Subdivision approval to create two (2) legal lots of record from one (1) metes-and-bounds parcel.

INGATE PLACE SUBDIVISION, RESUBDIVISION OF LOT 11 AND PART OF LOTS 9 & 10

APPLICATION NUMBER ______15 DATE ____June 20, 2024

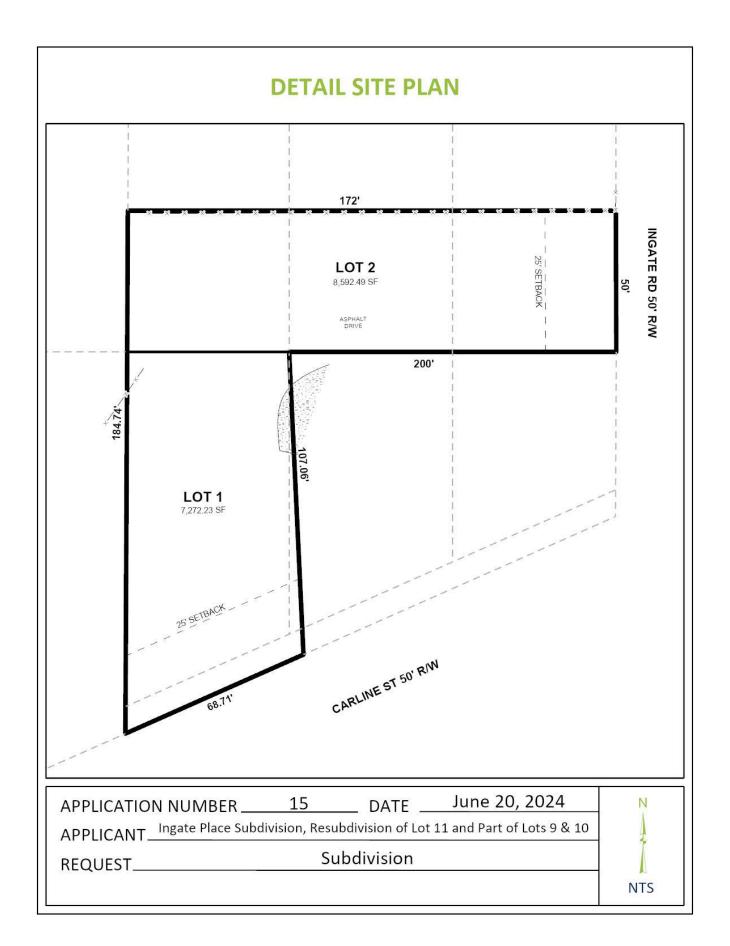
Proposed Lot 1 has frontage along Old Carline Street, a minor street without curb and gutter requiring a 60-foot right-of-way width. The preliminary plat depicts a 50-foot right-of-way at this location, which is substandard; however, subdivision of property to the West in 2018, at the Northeast corner of Furr Street and Old Carline Street, was approved with a 50-foot right-of-way along Old Carline Street. As such, retention of the 50-foot right-of-way width may be appropriate. A waiver of Section 6.B.9 of the Subdivision Regulations will be required for approval of the request.

The plat incorrectly labels Old Carline Street as "Carline Street." If approved, revision of the plat to correctly label Old Carline Street should be required.

Proposed Lot 2 has frontage along Ingate Street, a minor street with curb and gutter requiring a 50-foot right-of-way width. The preliminary plat depicts sufficient right-of-way at this location making additional dedication unnecessary.

The plat incorrectly labels Ingate Street as "Ingate Road." If approved, revision of the plat to correctly label Ingate Street should be required.

The lots, as proposed, exceed the minimum size requirements for lots served by public water and sanitary sewer in an R-1, Single-Family Residential Urban District, and are labeled in both square feet and acres on the preliminary plat, as required by Section 5.A.2(e)(4) of the Subdivision Regulations. If approved, this information should be retained on the Final Plat; or provision of a table on the Final Plat with the same information will suffice.

A 25-foot front yard setback is illustrated along both street frontages, but only a five (5)-foot front yard setback is required for lots in an R-1, Single-Family Residential Urban District, per Article 2 Section 64-2-5.E of the Unified Development Code (UDC). The applicant may retain the 25-foot setback, but if the plat is approved and recorded in Mobile County Probate Court with a 25-foot front yard setback, future development of the properties will be subject to a front yard setback that is greater than was is required by the UDC. As such, at least a five (5)-foot front yard setback should be illustrated along Old Carline Street and Ingate Street on the Final Plat, if approved.

- 1. Retention of the 50-foot rights-of-way along Old Carline Street and Ingate Street;
- 2. Revision of the Final Plat to correctly label Old Carline Street and Ingate Street;
- 3. Retention of the lot sizes in both square feet and acres, or provision of a table on the Final Plat providing the same information;
- 4. Retention of at least a five (5)-foot front yard setback along Old Carline Street and Ingate Street, as required by Section 64-2-5.E of the Unified Development Code;
- 5. Compliance with all Engineering comments noted in this staff report;
- 6. Placement of a note on the Final Plat stating all Traffic Engineering comments noted in this staff report;
- 7. Compliance with all Urban Forestry comments noted in this staff report; and,
- 8. Compliance with all Fire Department comments noted in this staff report.
